Poynton Lake
Report of the Result of a Periodic Inspection
under Section 10(5) of the Reservoirs Act 1975

On 20 May 2005

By [REDACTED] CEng, FICE, MCIWEM

August 2005

Photograph 7 – Fallen tree

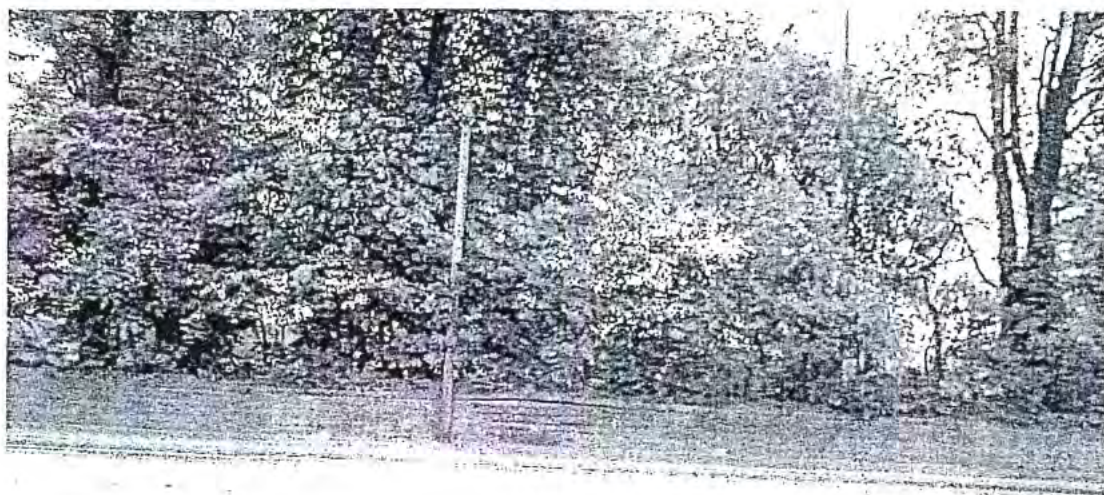
The crest of the embankment is protected by stone on the line of the footpath around the water's edge. This path is being well maintained and is free from settlement or other damage (Photograph 3 & 4). The crest is relatively extensive and a grassed area rises slightly downstream of the track on the crest. This grassed area is approximately 8-10m wide and is extensively covered in trees, some of which are relatively mature. There are also trees along the upstream edge of the crest. These are generally secure but some have been undercut and have fallen, or are in the process of failing, into the reservoir (Photograph 5, 6 & 7). It would be

prudent to monitor the condition of all of the trees on the crest and to cut these back as and when appropriate to avoid them falling.

- (a) Repair any areas of erosion along the upstream face.
- (b) Cut back any trees in danger of toppling.
- (c) Remove any trees which have fallen into the reservoir
- (d) Investigate the potential for out of bank flow from the Brook to the south of the reservoir to flow into the reservoir by an overland route rather than via the existing pipe.
